**Eastonville Road – Londonderry Dr. to Rex Road
Segment 1 Improvements
Stationing 14+55.00 – 47+00.00**

Final Drainage Report

January 2024

[See comment letter also.](#)

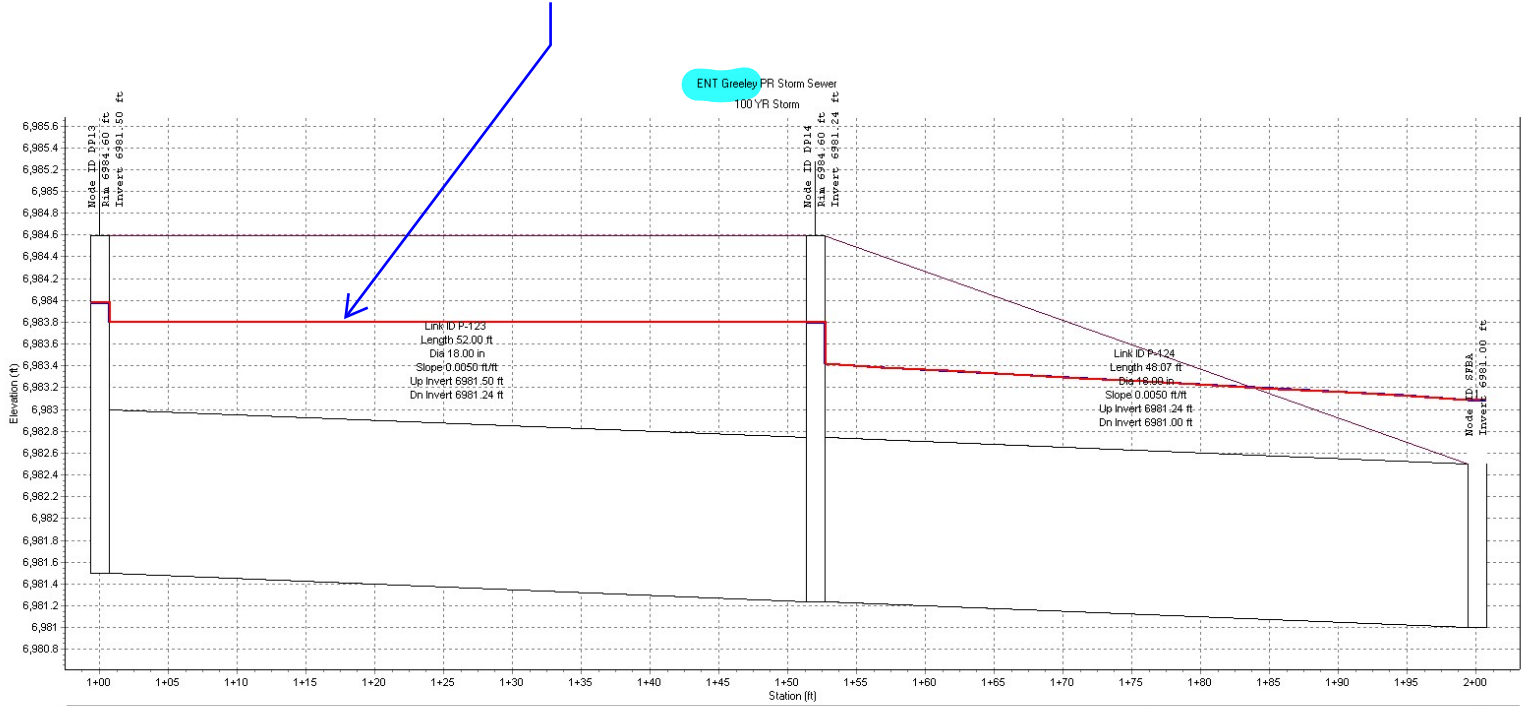
If surcharge is unavoidable
specify watertight joints on CDs.
Verify that 5-yr HGL is in pipe

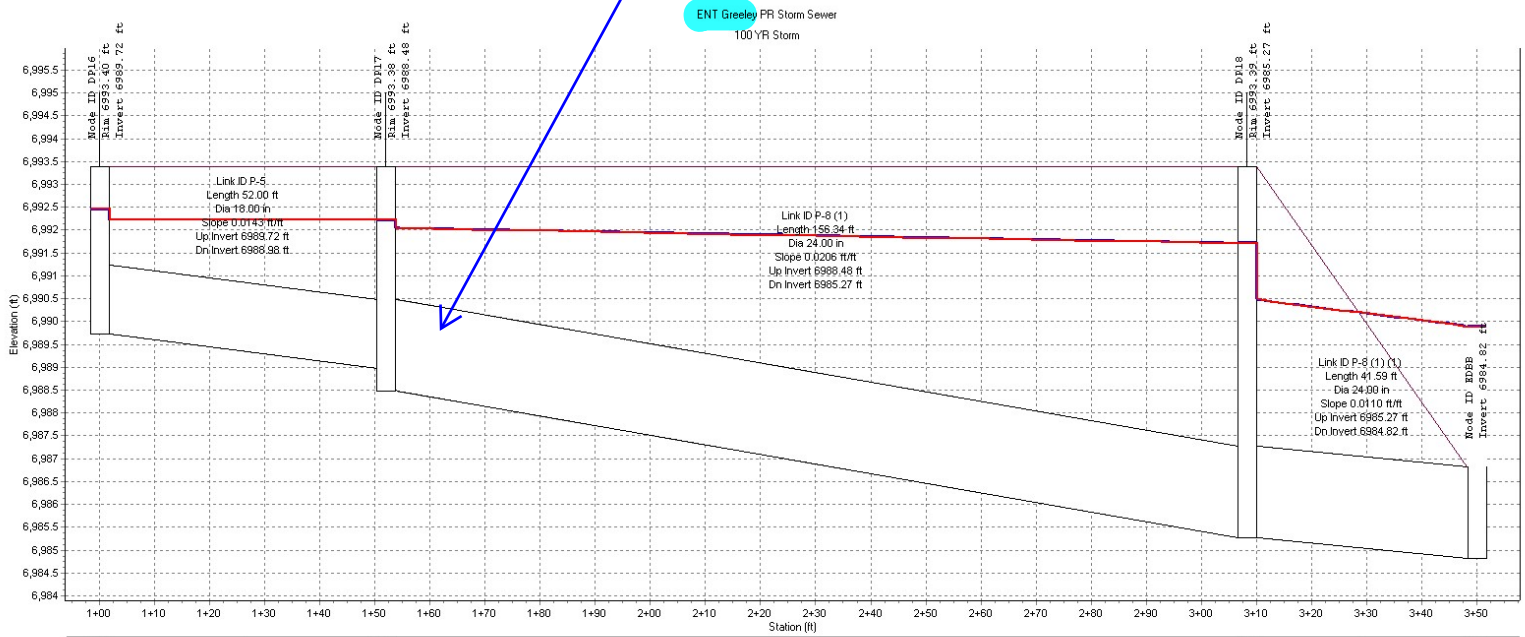
verify that 5-yr
HGL is in pipe

DETENTION BASIN STAGE-STORAGE TABLE BUILDER

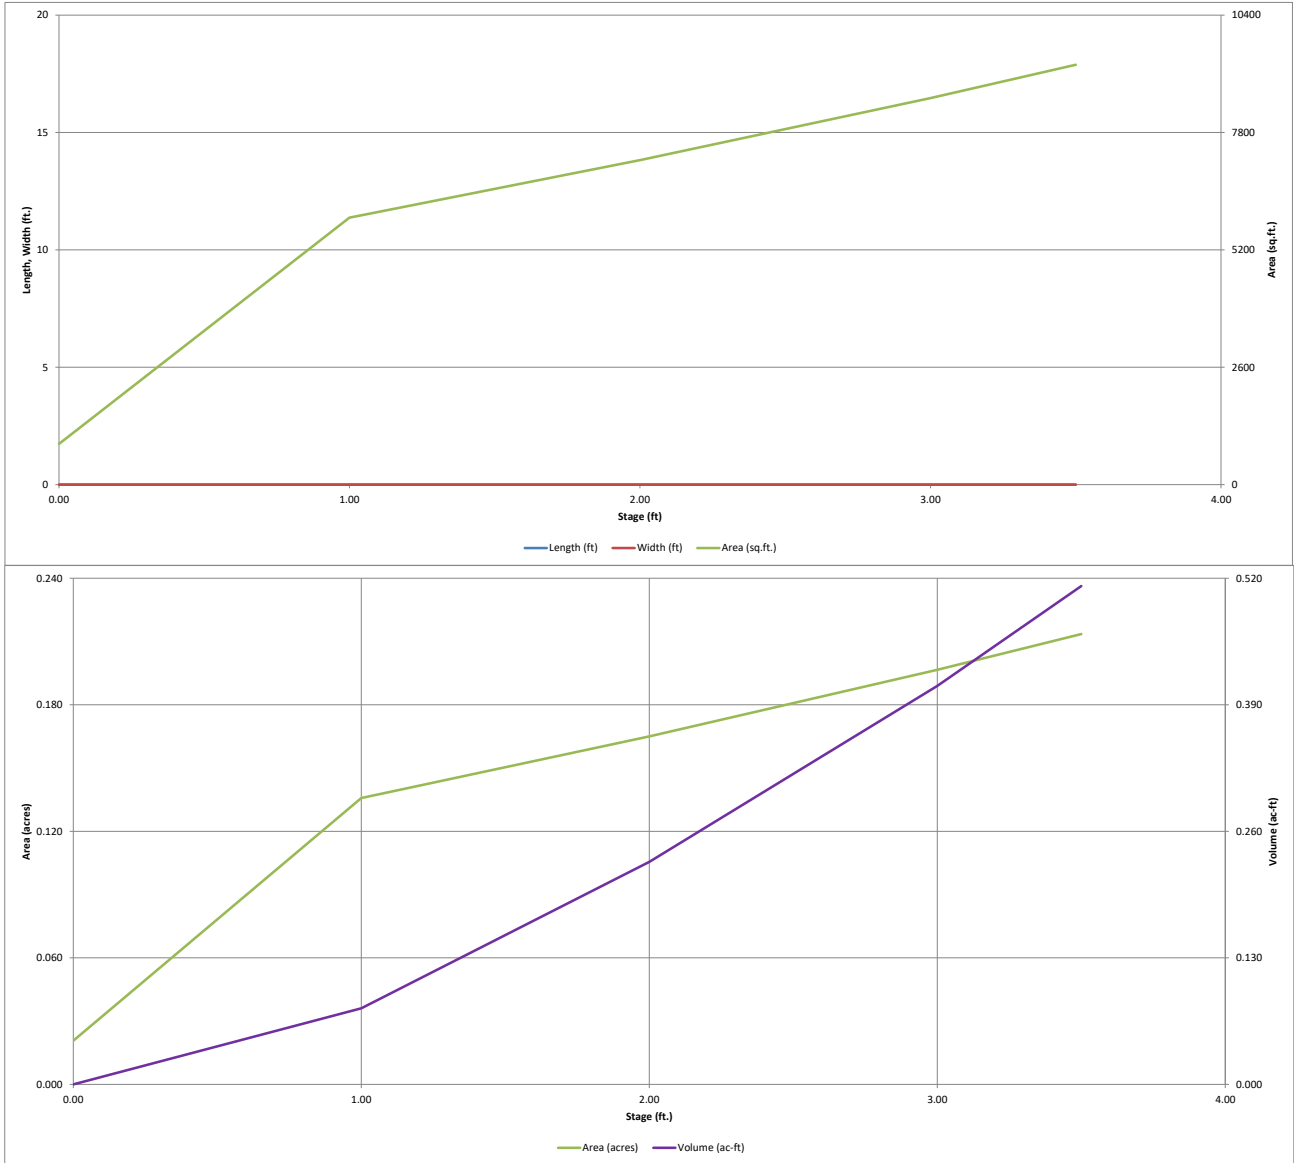
Shown as 15/16" on UD-BMP calcs above. Revise to remove discrepancy.

DETENTION BASIN OUTLET STRUCTURE DESIGN

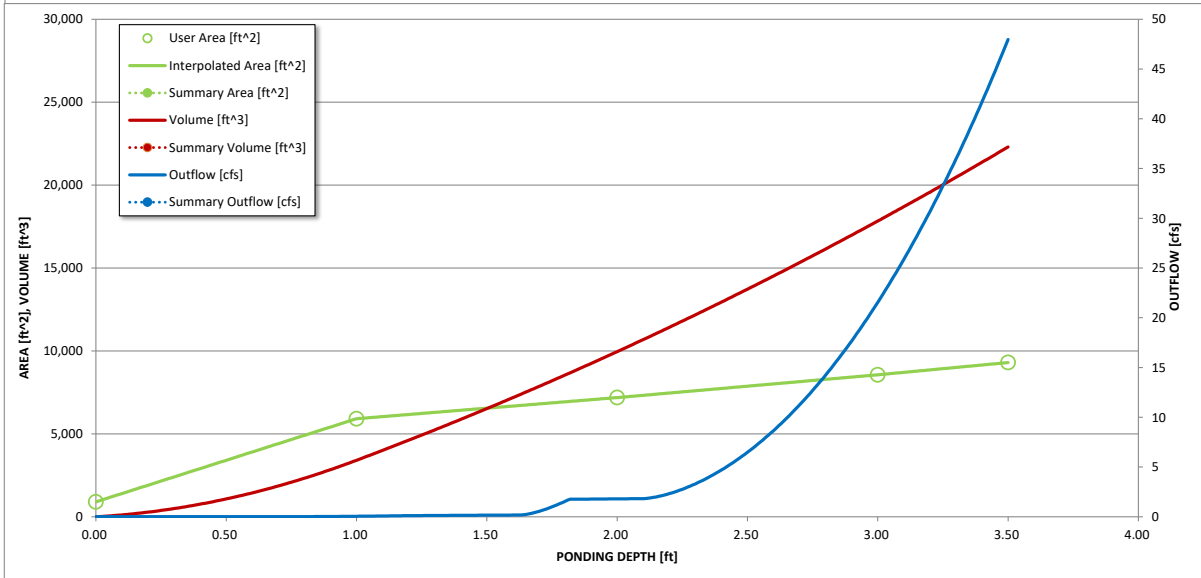
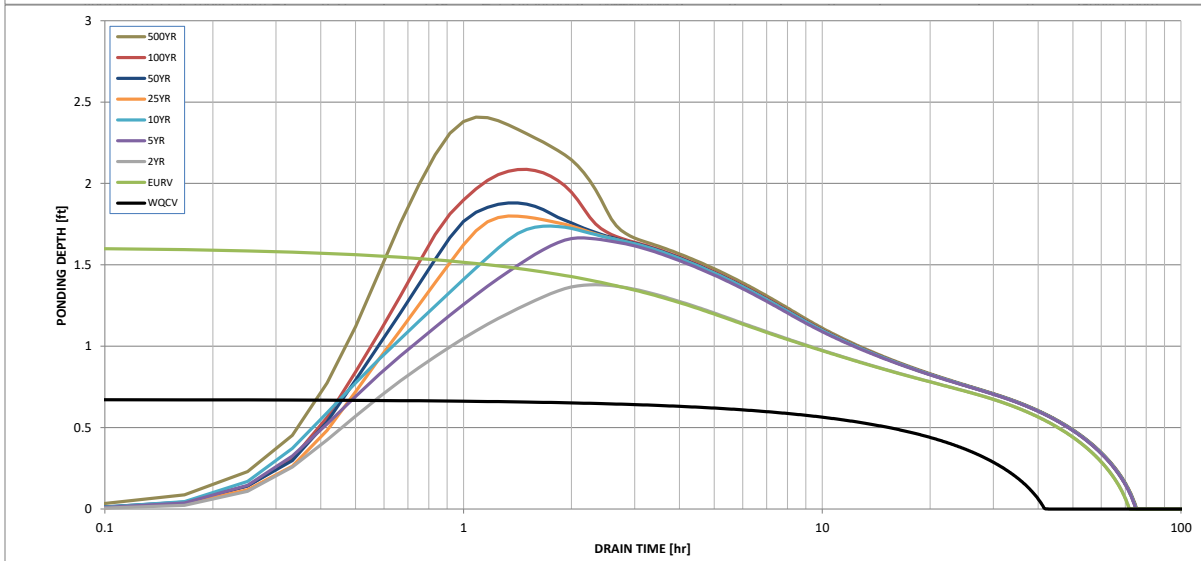
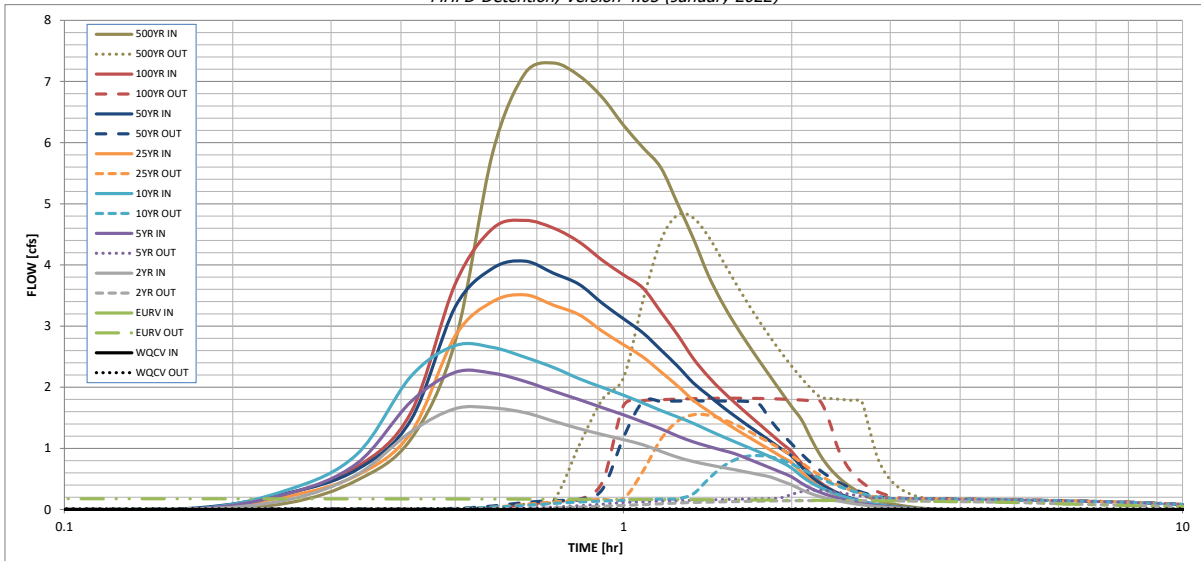
this is significantly lower than 8.4 cfs calculated -- verify input data

DETENTION BASIN OUTLET STRUCTURE DESIGN

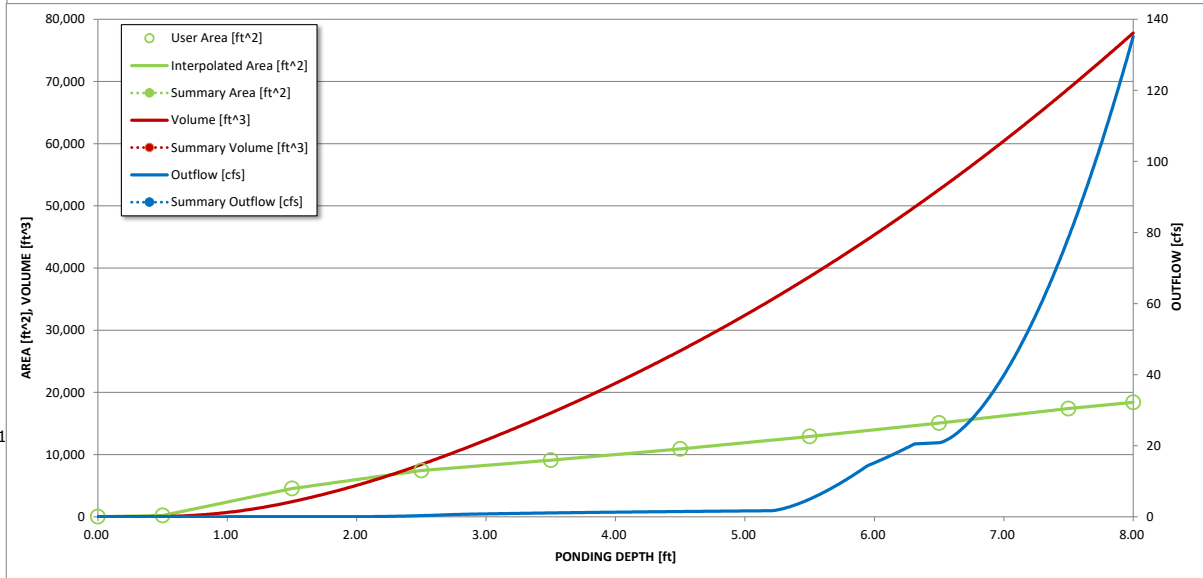
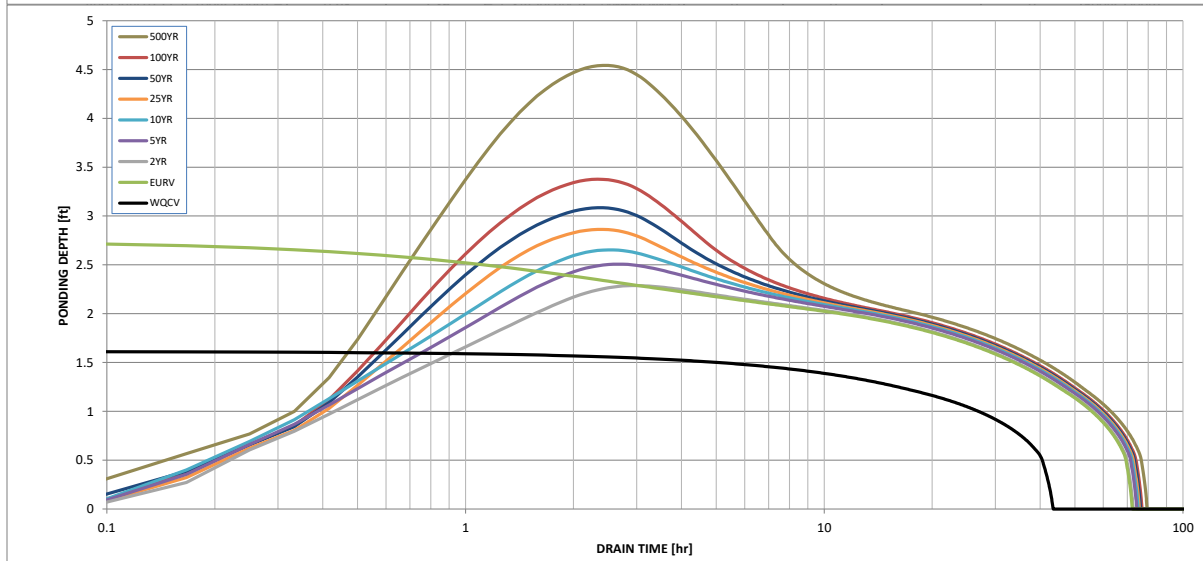
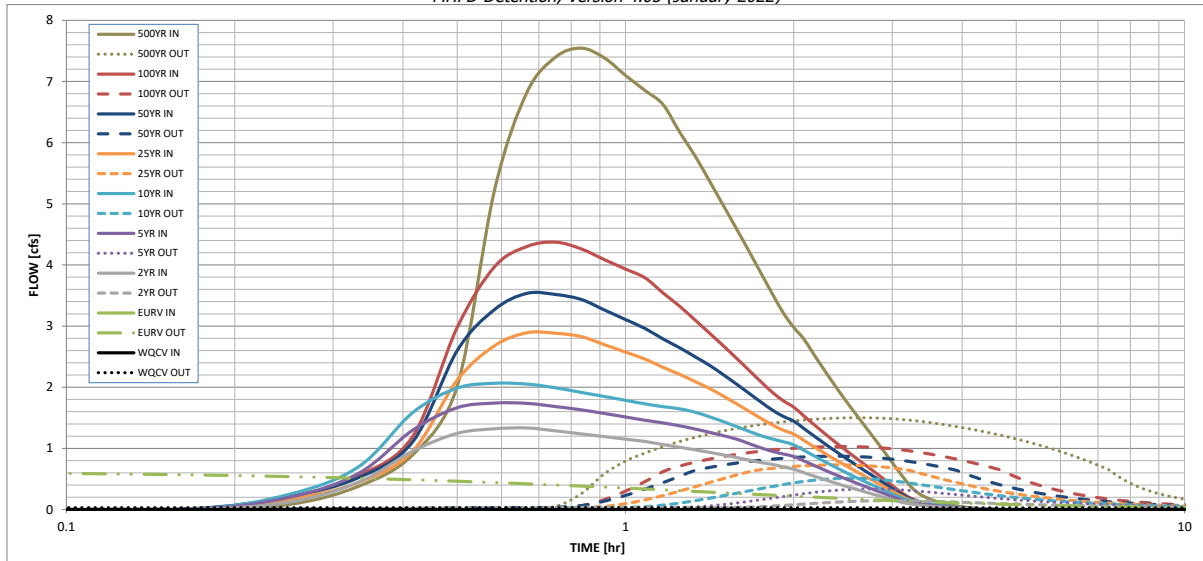
this is significantly lower than 10.9 cfs calculated -- verify input data

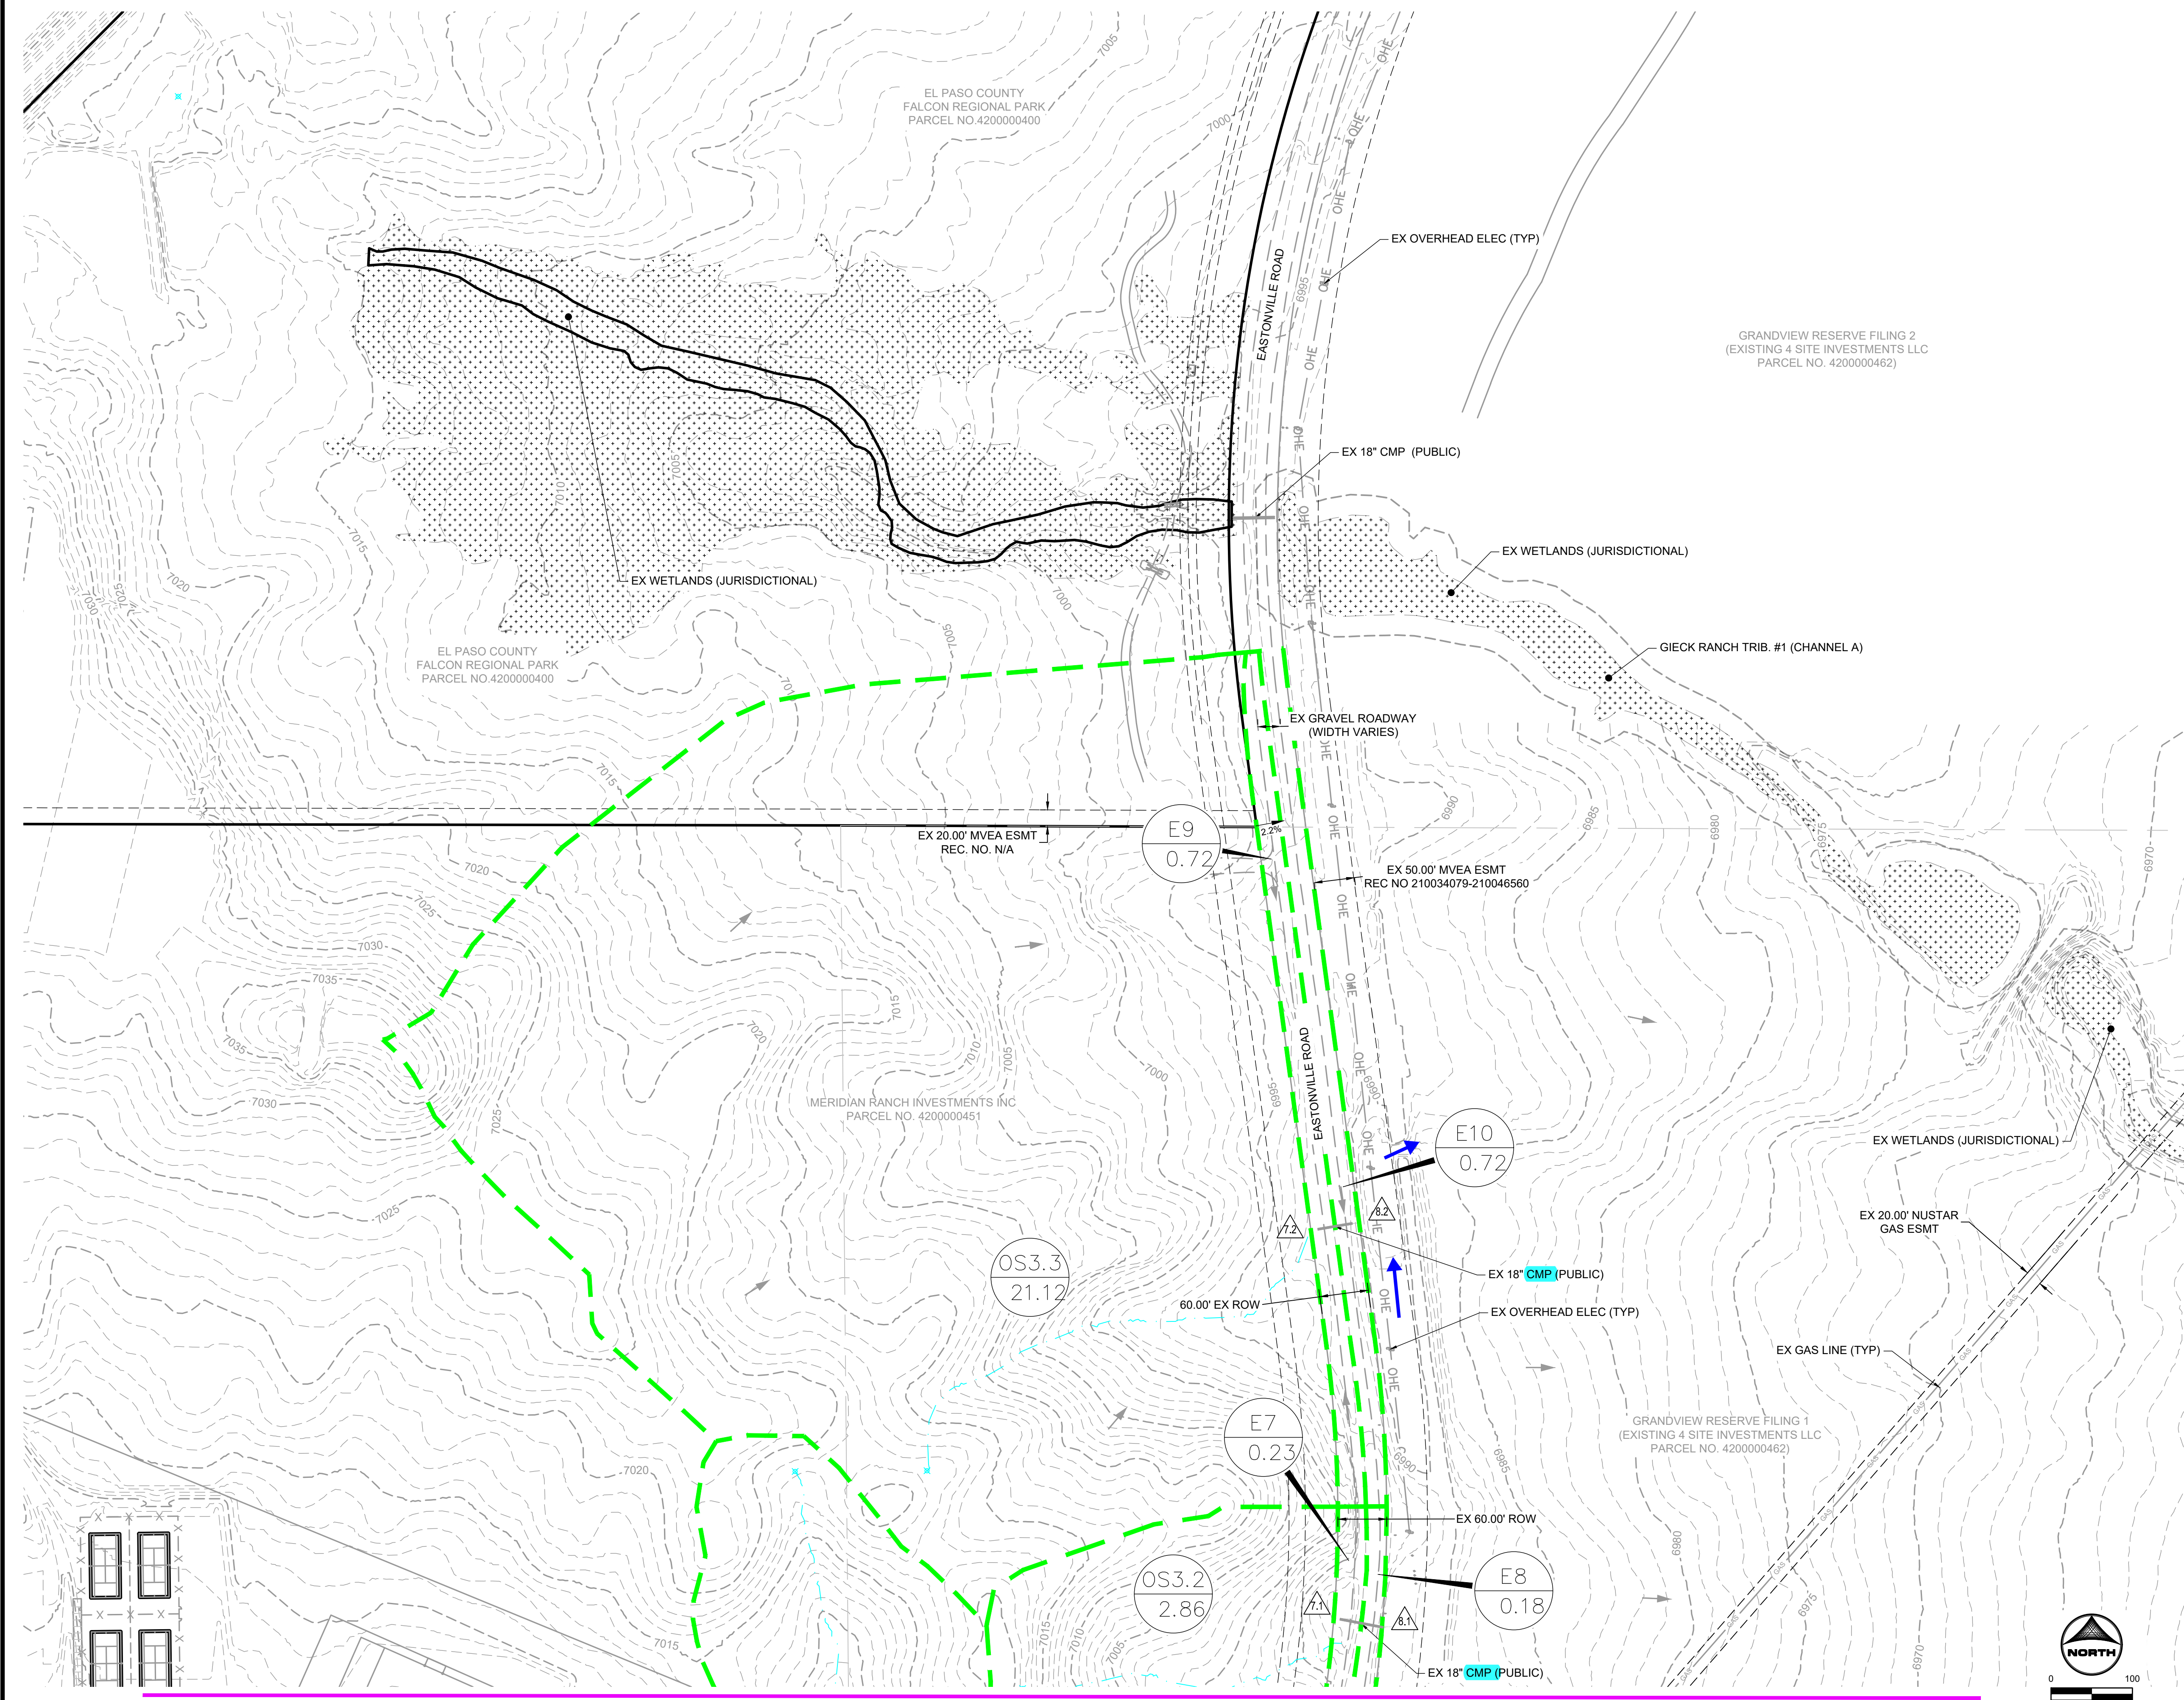
Provide existing drainage plans
